# SOUTHERN CALIFORNIA EDISON'S DEVERS-MIRAGE 115 KV SUBTRANSMISSION SYSTEM SPLIT PROJECT

Final Environmental Impact Report  
(Response to Comments)

CPUC A.08-01-029  
SCH#: 2008041087

Attachment 2

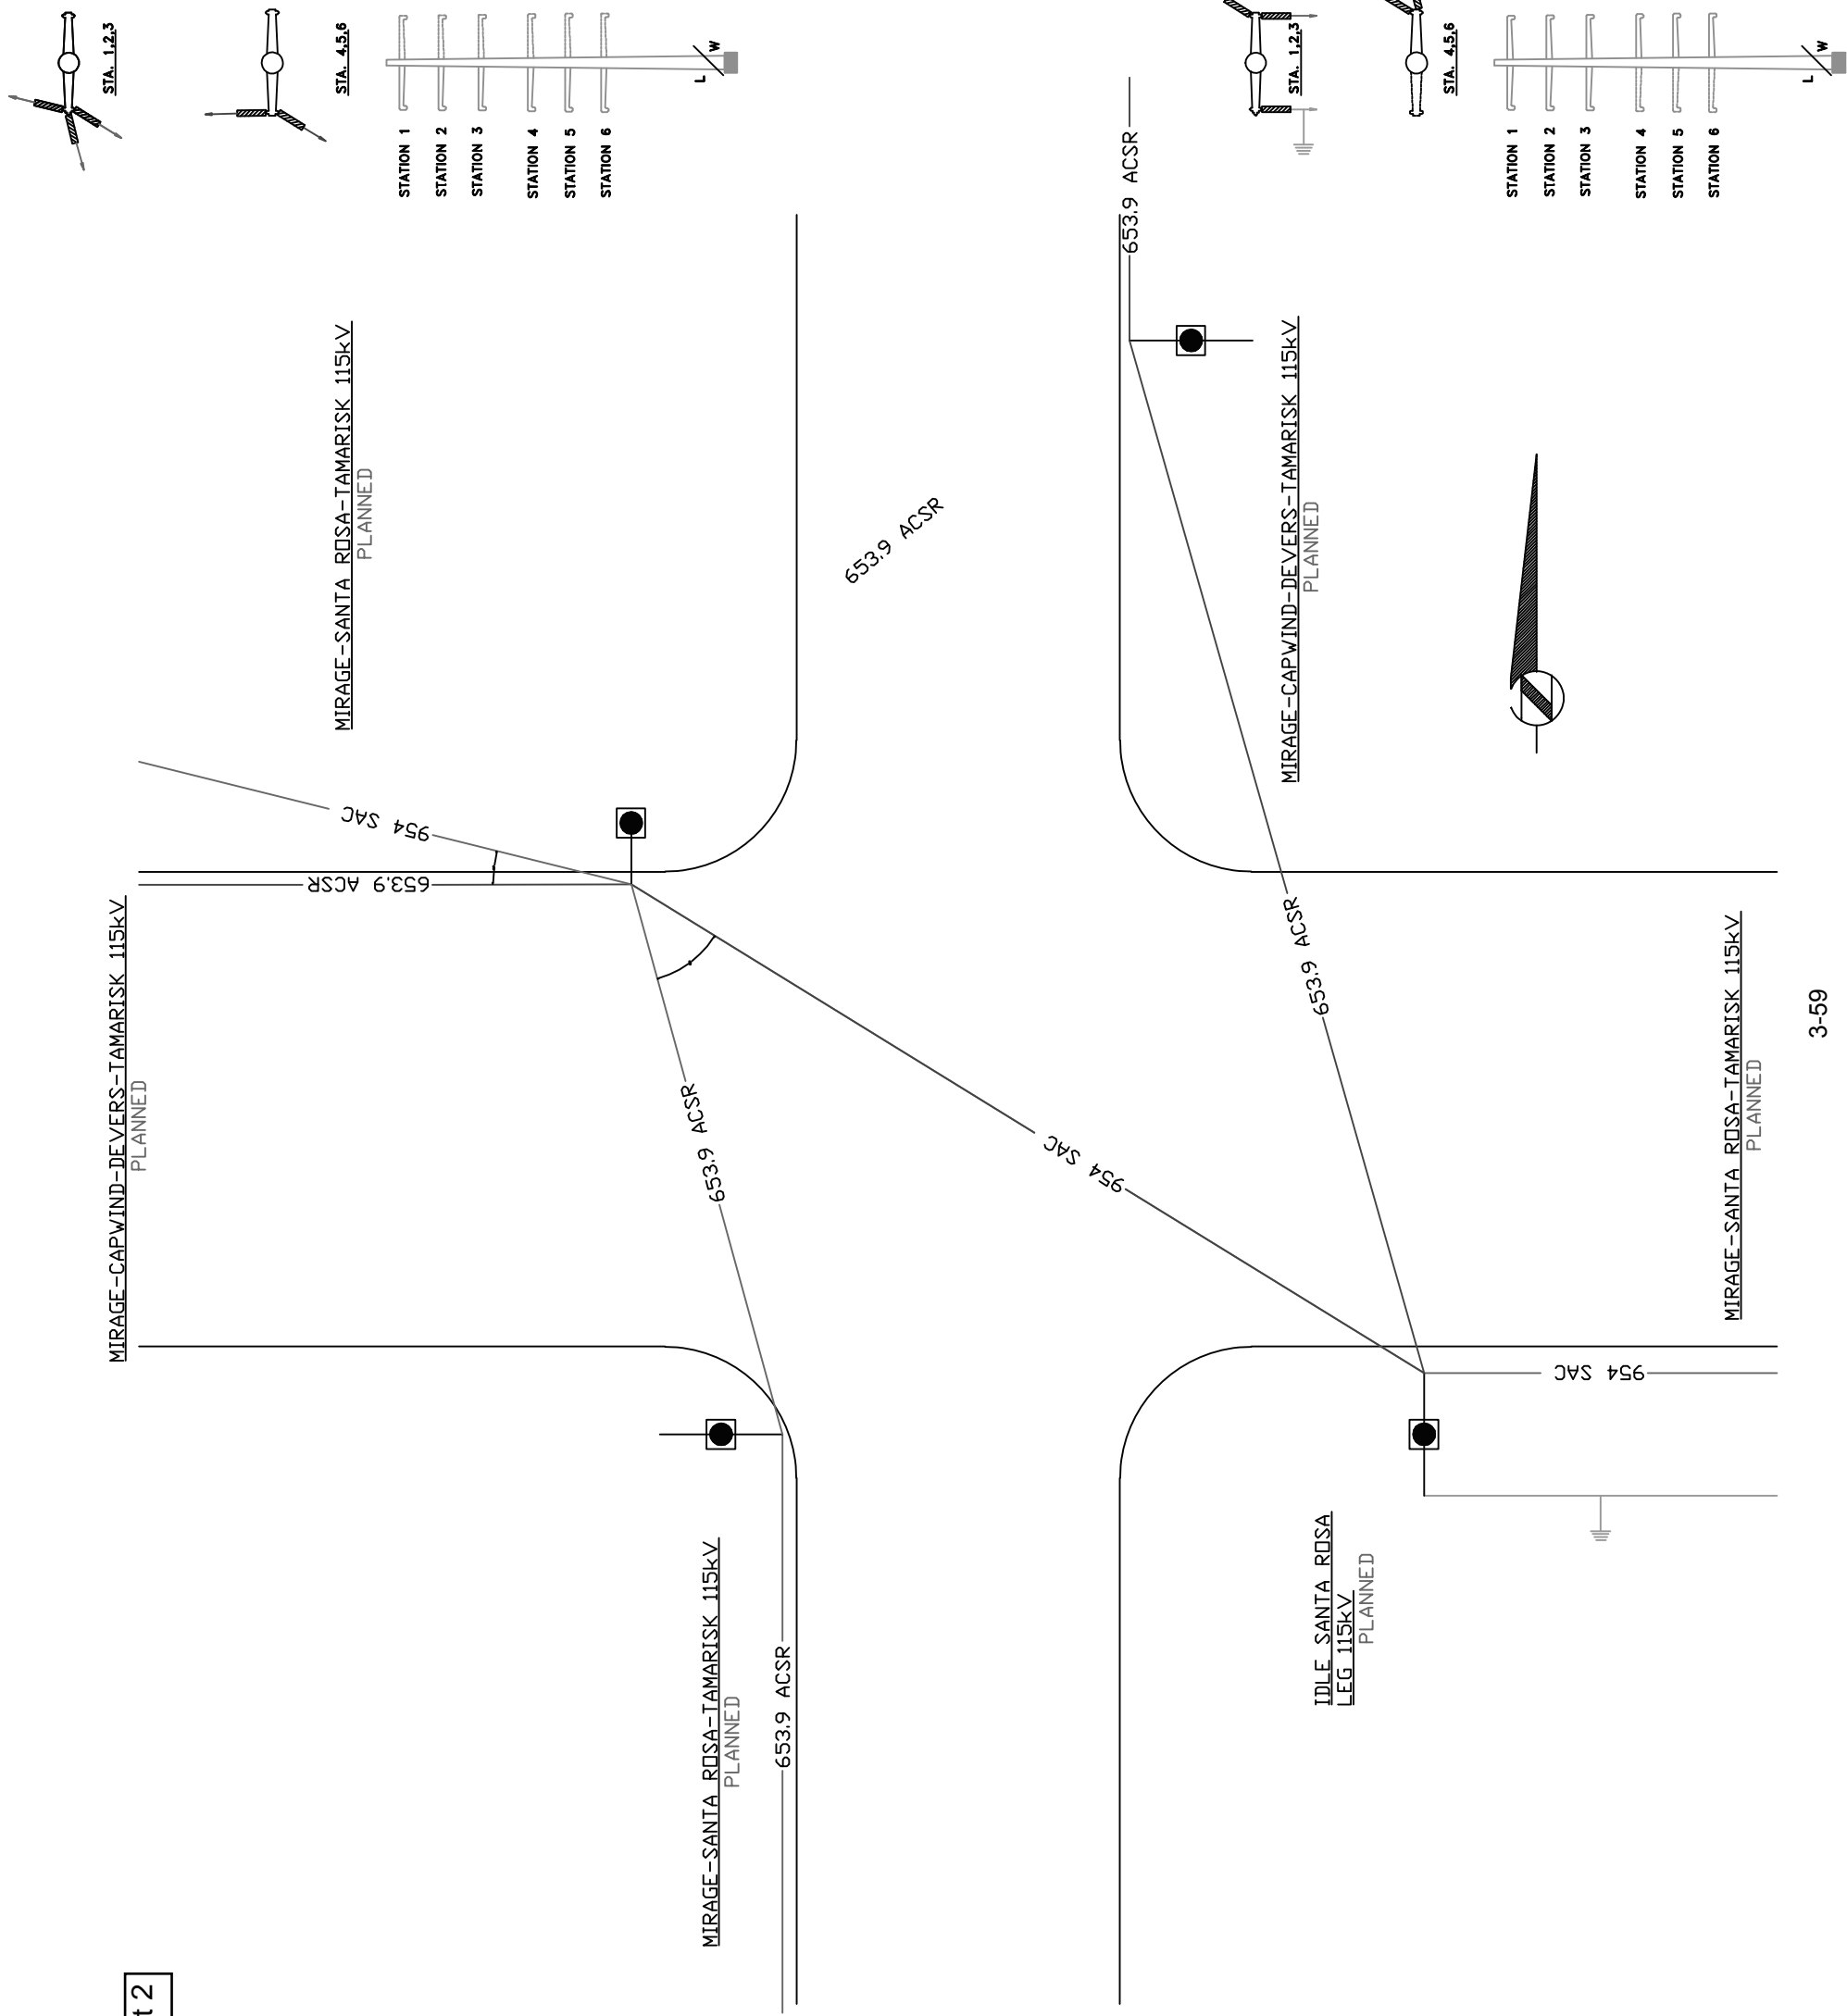
<b>Comment Number</b>	<b>Page Number</b>	<b>Comment</b>	<b>Suggested Revision</b>
12	2-13/ Bullet 1	As a result of more extensive engineering and to enhance the appearance of the pole, the pole configuration was changed. Therefore, please revise the first bullet as follows:	<ul style="list-style-type: none"> <li>Split the existing Garnet-Santa Rosa 115 kV subtransmission line at the intersection of Bob Hope Drive and Dinah Shore Drive by removing the span of wire that connects the southwest and northeast corner poles and transfer it to the southeast corner pole (see Figure 2-5, Existing and Proposed 115 kV Line Configurations at Bob Hope and Dinah Shore Drives).</li> </ul>
13	2-14/ Fig. 2-5	Based on updated engineering information, please change proposed conductor configuration to look like the attached drawing:	See Attachment 2, Updated Subtransmission Line Configurations
14	2-18/ Bullet 1	Based on updated engineering information, please revise bullet to the following: "...at the southeast corner..."	"Install a span of conductor between the existing north segment of the Garnet-Santa Rosa 115 kV subtransmission line and the existing west segment of the Santa Rosa-Tamarisk 115 kV subtransmission line at the <del>northwest</del> southeast corner of Bob Hope Drive and Dinah Shore Drive."

- Response O2-13 The Applicant has provided an updated drawing depicting the changed conductor configuration at Bob Hope and Dinah Shore Drives (Figure 2-5 in the Draft EIR). The updated drawing is provided as Attachment 2 to Comment Letter O2. No substantive changes to the environmental analysis are made necessary by this minor change.

Attachment 3

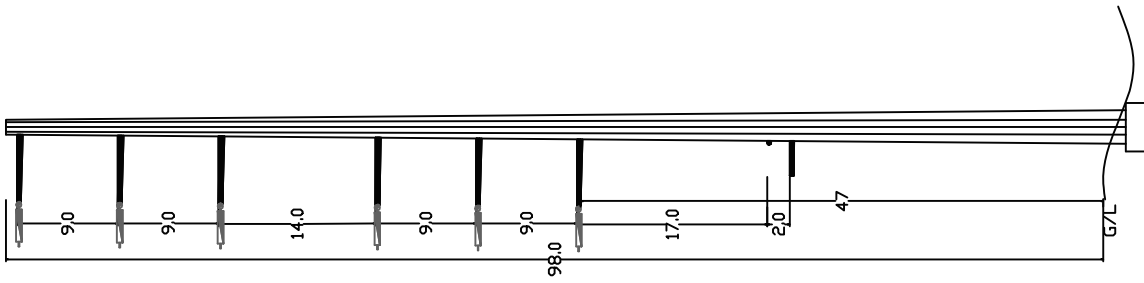
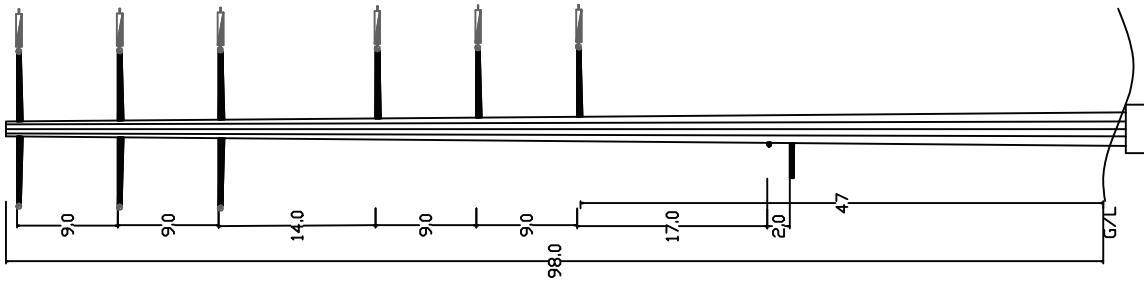
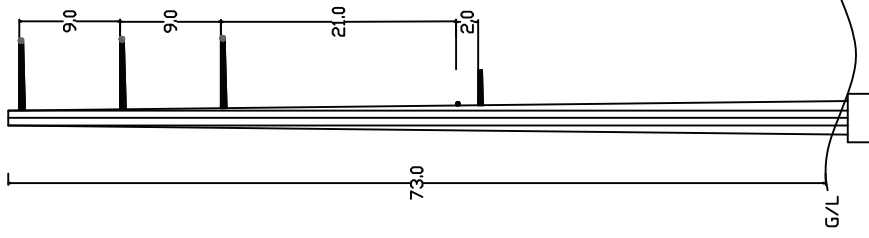
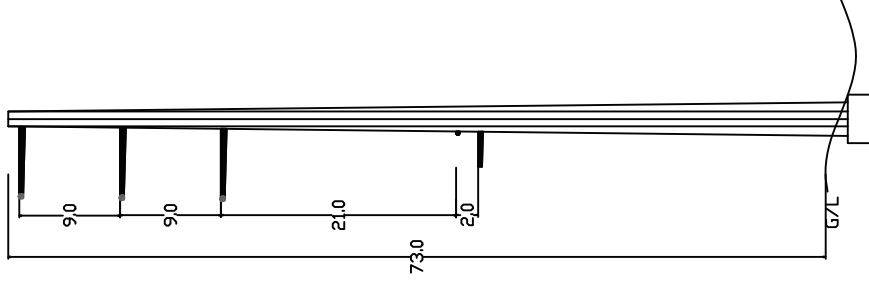
15	2-21/ Fig. 2-8	Based on updated engineering information, please change Figure 2-8 to the attached figure:	See Attachment 3, Bob Hope Dr. TSP Profile

- Response O2-15 The Applicant has provided an updated drawing depicting the changed TSP profile at Bob Hope Drive (Figure 2-8 in the Draft EIR). The updated drawing is provided as Attachment 3 to Comment Letter O2. No substantive changes to the environmental analysis are made necessary by this minor change.

Devers-Mirage 115 kV Subtransmission System Split Project - 207059  
**Figure ES-1**  
 Proposed Project and Alternatives Electrical Needs Area

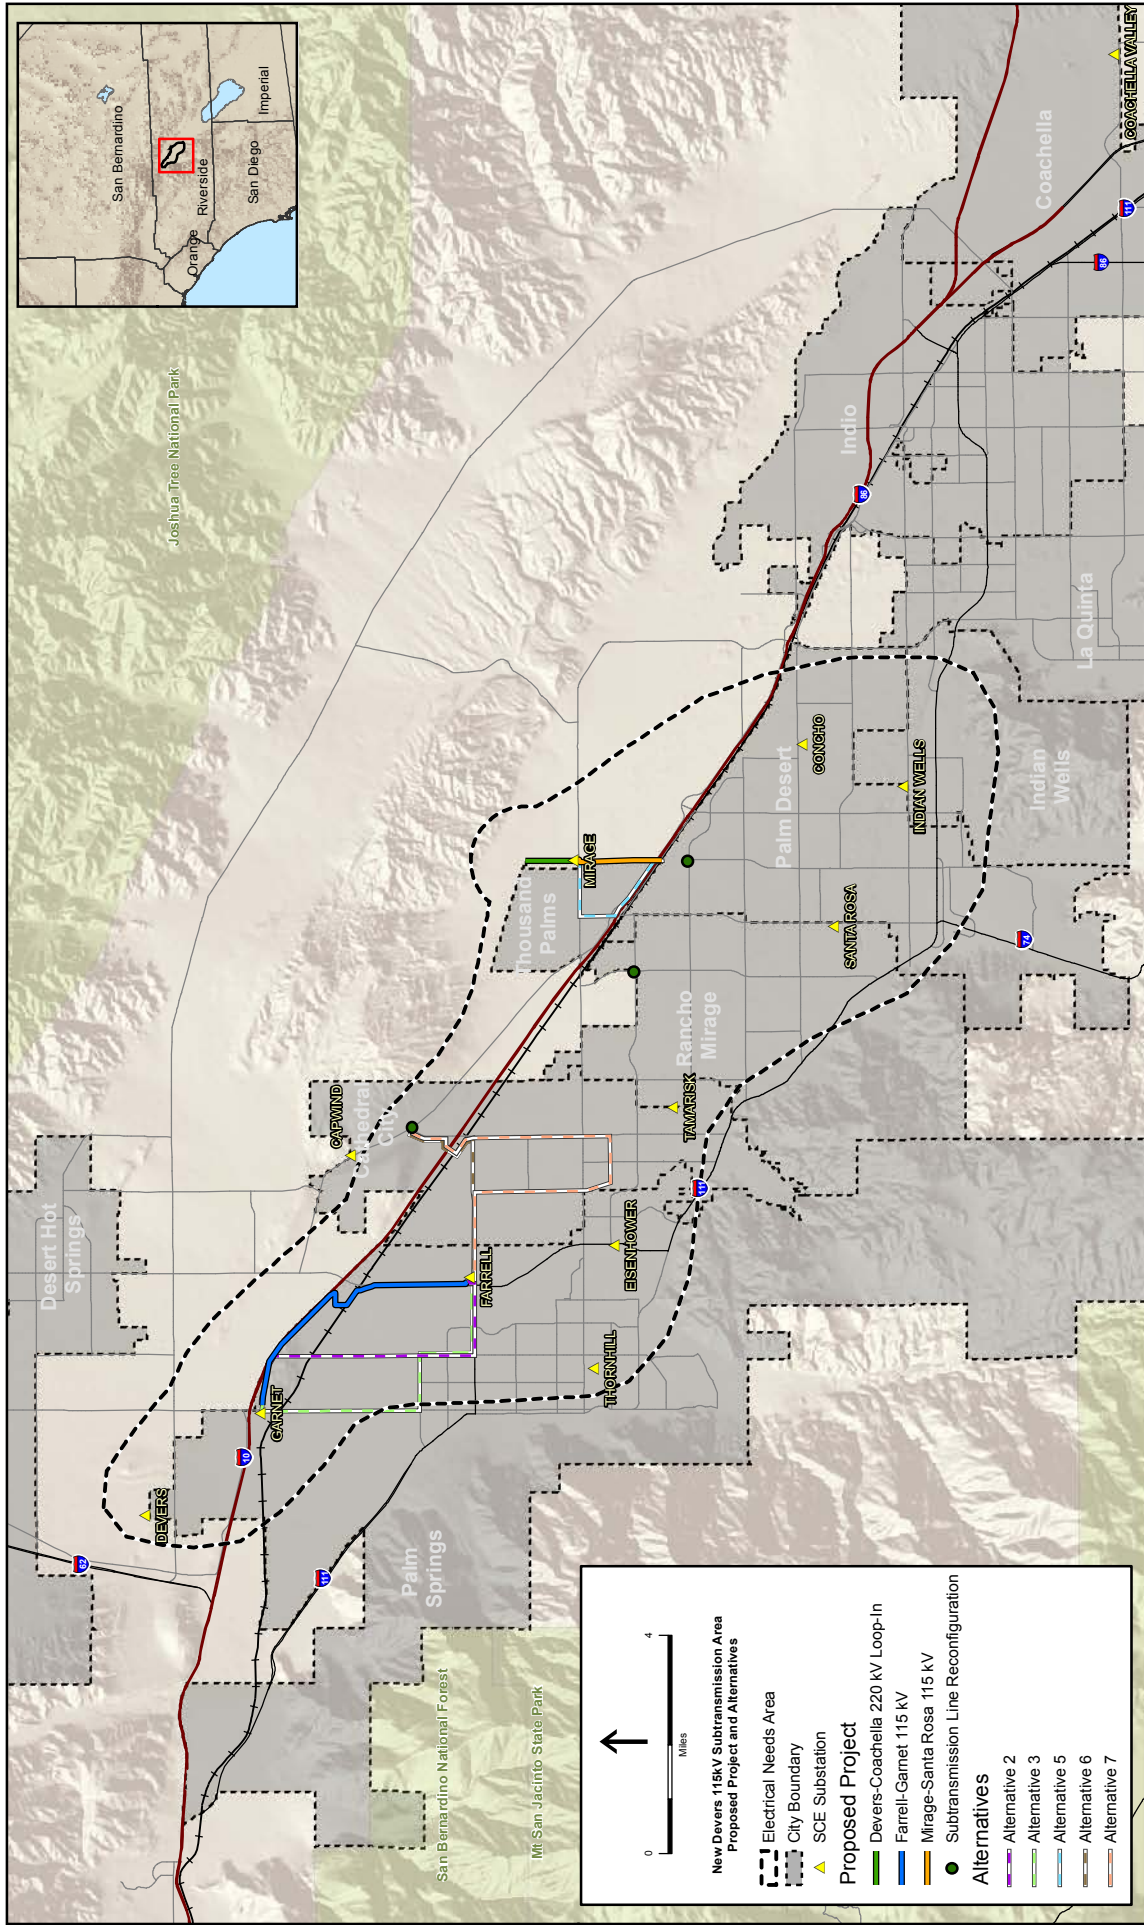
Comment Number	Page Number	Comment	Suggested Revision
3	ES-9/Fig. ES-2	The figure shows Alternative 3 stopping where it meets Alternative 2. The figure should depict Alternative 3 turning along Alternative 2 and running adjacent to it until it reaches the Farrell Substation icon.	Please amend Figure ES-2 to reflect the fact that Alternative 3 continues into Farrell substation.
4	ES-4	Originally it was thought that five new circuit breakers would be needed to accommodate a new line position. However, a more efficient configuration has been incorporated into the design and instead of five circuit breakers, only three will be needed. Please revise the language under Mirage Substation to reflect this configuration.	<ul style="list-style-type: none"> <li>Install five new 220kV circuit breakers and <del>five</del> <u>three</u> new 115kV circuit breakers</li> </ul>
5	ES-5	In order to provide a more detailed explanation of the work at Santa Rosa Substation and to be consistent with other substation descriptions, please replace the first bullet under Santa Rosa substation with the two bullets provided.	<ul style="list-style-type: none"> <li>Convert the existing Santa Rosa-Garnet 115 kV subtransmission line to the new Mirage-Santa Rosa-Tamarisk 115 kV subtransmission line</li> <li>Convert the existing Santa Rosa-Tamarisk 115 kV subtransmission line to the new Mirage-Santa Rosa 115kV subtransmission line</li> </ul>

- Response O2-3 Figures ES-1 and ES-2 have been revised to show that Alternative 3 would continue into Farrell Substation. The revised figures are included in Section 5 of this Response to Comments document.

**ES-2** *Figure ES-1 has been revised as shown on the following page.*

Devers-Mirage 115 kV Subtransmission System Split Project, 207059  
**Figure 4.1-1**  
 Visual Simulation Viewpoints

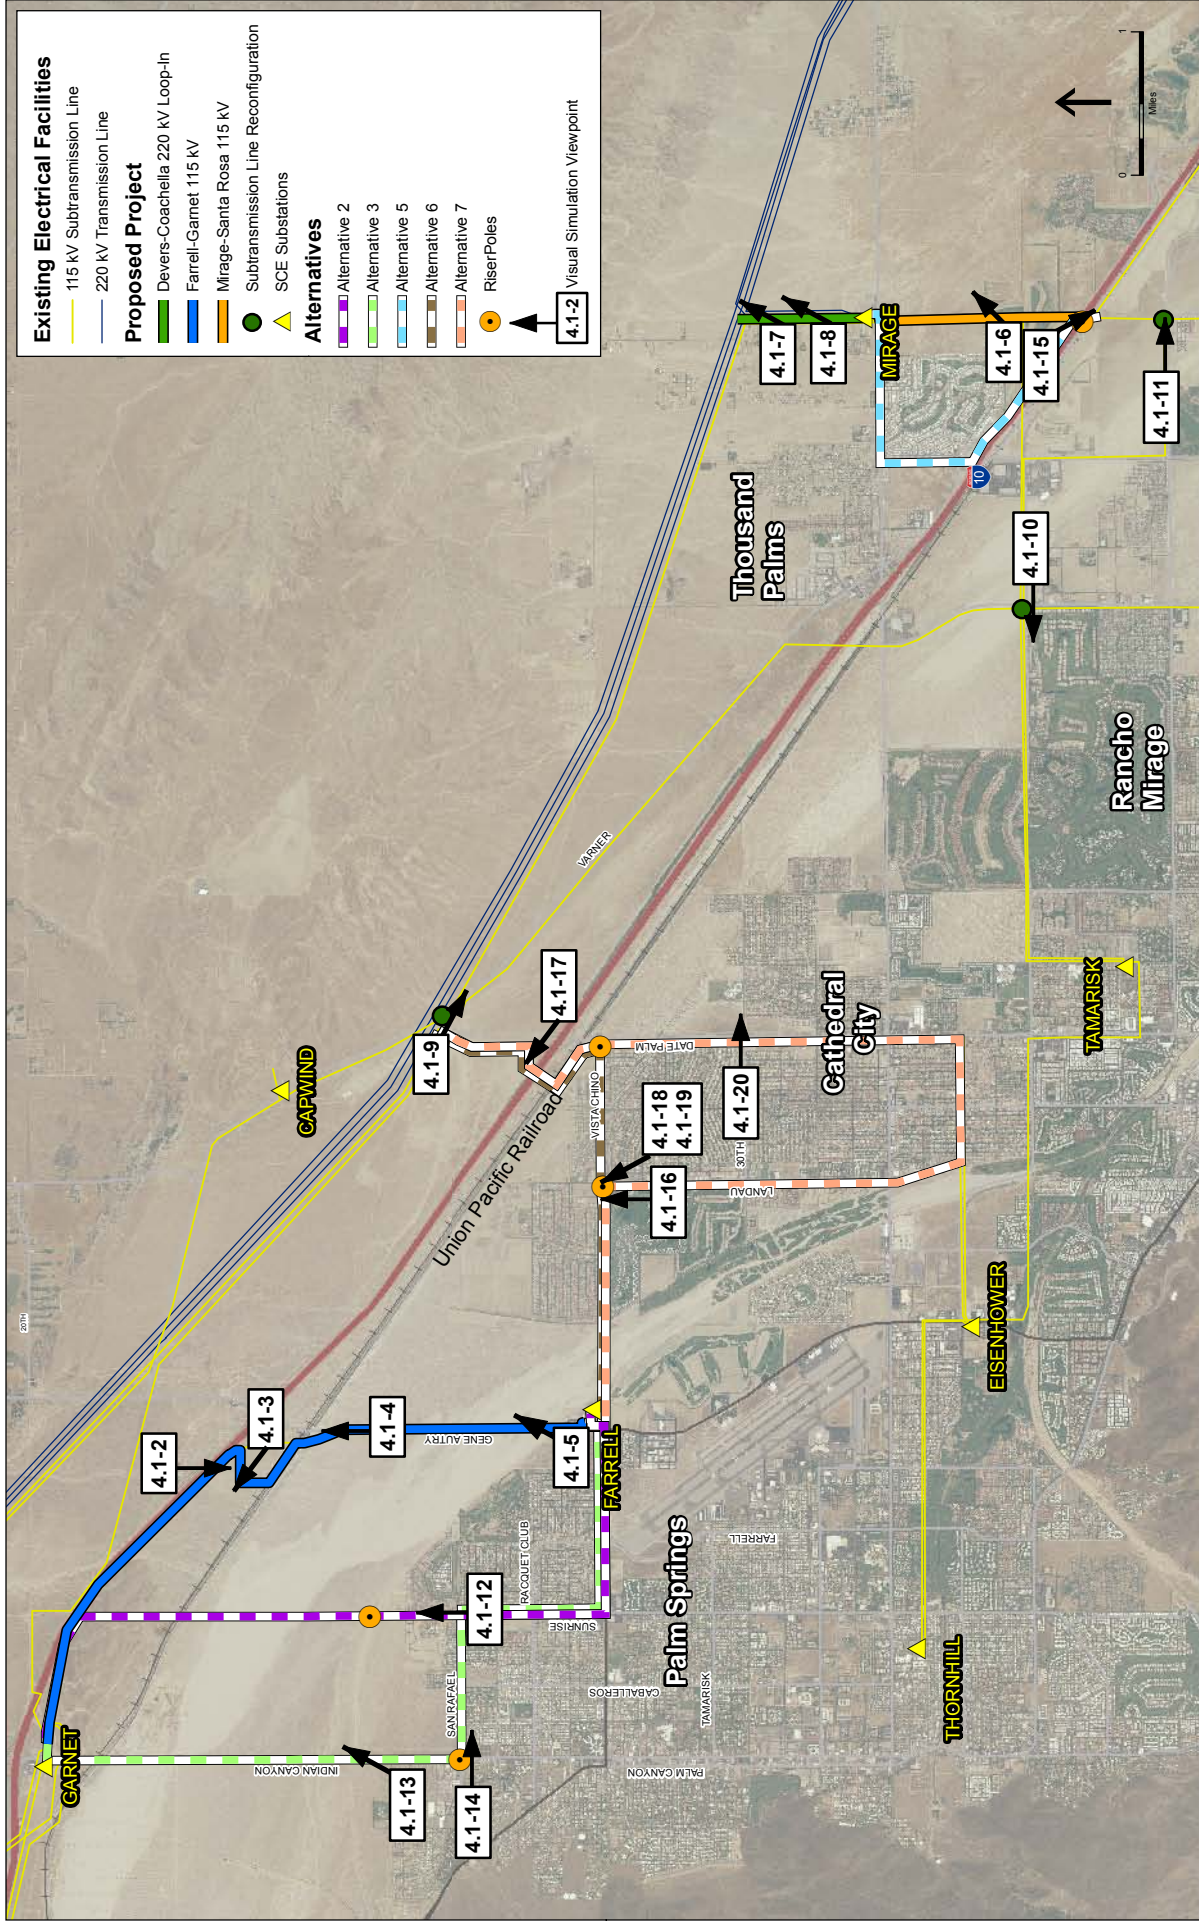
37	Figure 4.1-1	Map clarification needed.	Please label SR 111 (Vista Chino); Add symbology that indicates the underground portions; offset the alternatives so that the reader can tell where they overlap instead of just seeing the top most layer.
<b>Air Quality</b>

- Response O2-37 Figure 4.1-1 in Section 4.1, *Aesthetics*, has been updated and clarified. The updated figure is included in Section 5 of this Response to Comments document.

**4.1-14** *Figure 4.1-1 has been updated as shown of the following page.*
